LETTER OF TRANSMITTAL

SUBJECT: **MAINE STATE PLANNING OFFICE – DOLBY LANDFILL
OPERATING MANUAL AND ENVIRONMENTAL MONITORING PLAN
REVISIONS (APRIL 2012)**

**OPERATING MANUAL
FOR
DOLBY III LANDFILL
EAST MILLINOCKET, MAINE**

Revised April 2012

FIGURE 2-1
 ORGANIZATION CHART
 FOR LANDFILL OPERATIONS
 DOLBY LANDFILL
 EAST MILLINOCKET, MAINE
 MAINE STATE PLANNING OFFICE

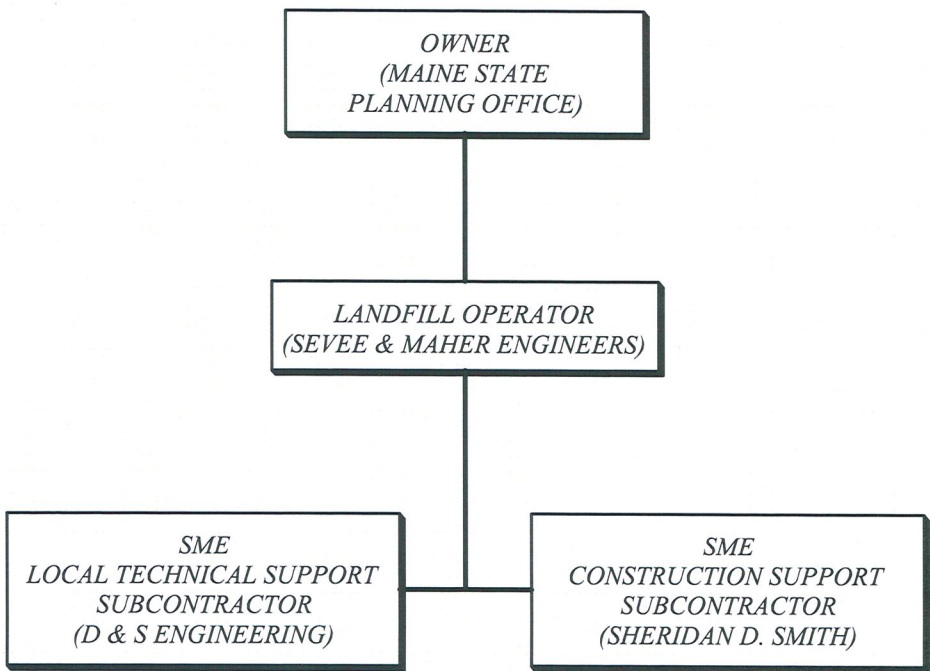
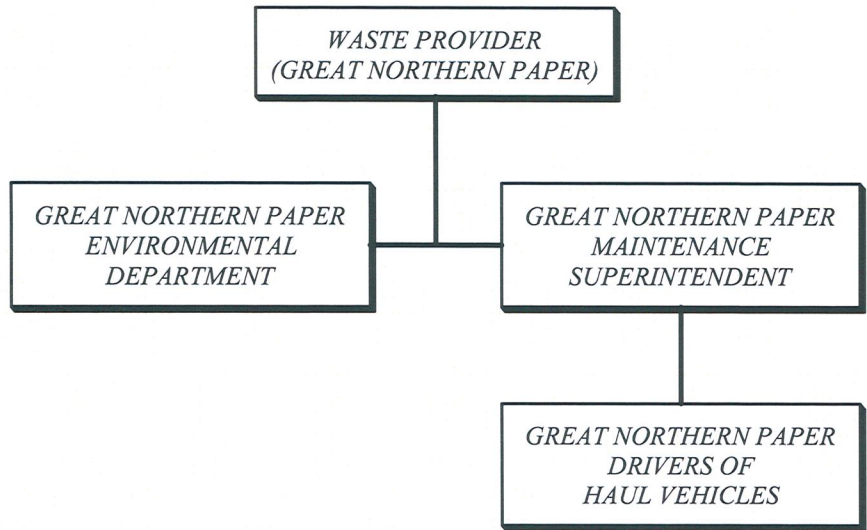
- Page 2-1 Section 2.0 and Page 2-2 Figure 2-1 – Updated landfill personnel information and organization chart.
- Page 4-1 Section 4.1.3, and Page 5-4 Section 5.3.1 – Updated to reflect the change in disposal location for East Millinocket Mill primary and secondary sludge after July of 2011 (no sludge taken to the landfill).
